### **AMENDMENTS TO FIRE CODE 2018 - 9<sup>th</sup> BATCH OF AMENDMENTS**

SCDF would like to issue the 9<sup>th</sup> batch of amendments to the Code of Practice for Fire Precautions in Buildings 2018 (Fire Code 2018). The amendments which were deliberated and accepted by the Fire Code Review Committee are attached as Annex A & Annex B of this circular.

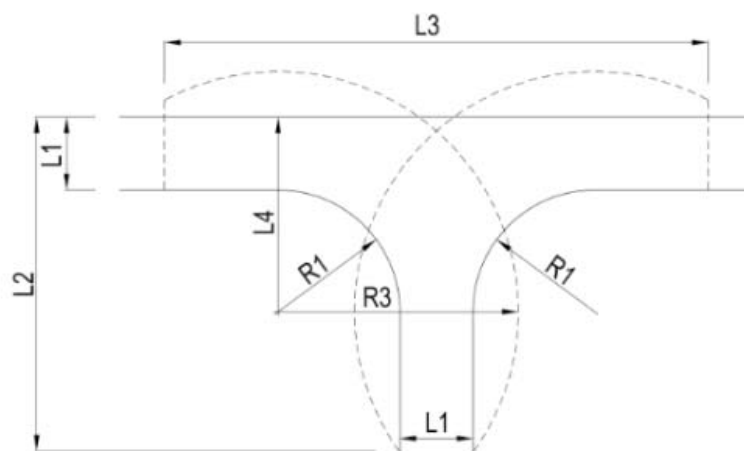
<p>d. All access hatches, if provided, shall be readily accessible from the roof. The access hatch opening shall have a minimum clear width of 1m in diameter.</p>	<p>d. The computation of travel distance for roof areas which are open to the sky for any purpose group (<del>except PG I</del>) can be based on the requirement for sprinkler-protected compartments/buildings.</p> <p>e. All access hatches, if provided, shall be readily accessible from the roof. The access hatch opening shall have a minimum clear width of 1m in diameter.</p>
32	10.4	01/09/2021	01/03/2022	New	Nil	<p><b>Electric Vehicle (EV) Charging Installation</b></p> <p><b>10.4.1 General</b></p> <p>The requirements in <i>Cl.10.4.2</i> are exempted for PG I buildings.</p> <p><b>10.4.2 Emergency main isolation shut-off switches</b></p> <p>a. Each EV charging station shall be provided with at least one emergency main isolation shut-off switch(es) located such that no person need to travel more than 15m from the EV charging station and its parking lot(s) to reach a main isolation shut-off switch.</p>

<ul style="list-style-type: none"><li>b. If more than one EV charging station is provided, the main isolation shut-off switch(es) shall be provided such that no person need to travel more than 15m from any EV charging station and its associated parking lot(s) to reach a main isolation shut-off switch.</li><li>c. Main isolation switch(es) shall be located on the same storey as the EV charging station(s) they serve. The purpose of such main isolation shut-off switch(es) is to provide a safe means of isolating the main electrical power supply to the entire EV charging system on the same storey.</li><li>d. Every EV charging stations and EV parking lots shall be located at least 3m away from the nearest edge of any main isolation shut-off switches.</li></ul> <p><u>Exception</u></p>
--	--	--	--	--	--	---

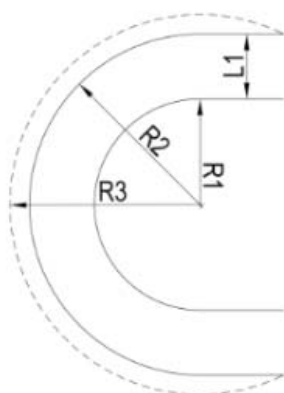
<p>Main isolation shut-off switches can be allowed to be less than 3m from an EV charging station and its parking lot(s), as long as there is at least one other main isolation shut-off switch located at least 3m away but still within 15m of this EV charging station and its parking lot(s).</p> <p>e. Main isolation shut-off switches shall be located between 800mm and 1.2m above the finished floor level and shall be located in a clearly visible and easily accessible location.</p> <p>f. All main isolation shut-off switches shall be clearly labelled. Clear instructions shall be indicated on how to operate the main isolation shut-off switch. Signages shall be provided with a letter height of at least 50mm.</p>
--	--	--	--	--	--	---

g. Where main isolation shut-off switch(es) cannot be seen clearly or not within line of sight from the EV charging station and its parking lot(s), additional signages shall be provided to direct persons to the main isolation shut-off switch(es).
33	<u>Table 4.2A</u>	01/09/2021	01/03/2022	Revised/ Clarification	Existing <u>Table 4.2A</u>	See <u>Annex B</u> (affected portions of <u>Table 4.2A</u> )
34	<u>Table 4.2C</u>	01/09/2021	01/03/2022	Revised/ Clarification	Existing <u>Table 4.2C</u>	See <u>Annex B</u> (affected portions of <u>Table 4.2C</u> )
35	Diagram 4.2.2e.	01/09/2021	01/03/2022	Revised/ Clarification	Existing <u>Diagram 4.2.2e.</u>	See <u>Annex B</u> (affectation portion of <u>Diagram 4.2.2e.</u> )
36	<u>Table 11A</u>	01/09/2021	01/03/2022	Revised/ Clarification	Existing <u>Table 11A</u> , items 7, 12 & 13	See <u>Annex B</u> (affected portions of <u>Table 11A</u> , items 7, 12 & 13)
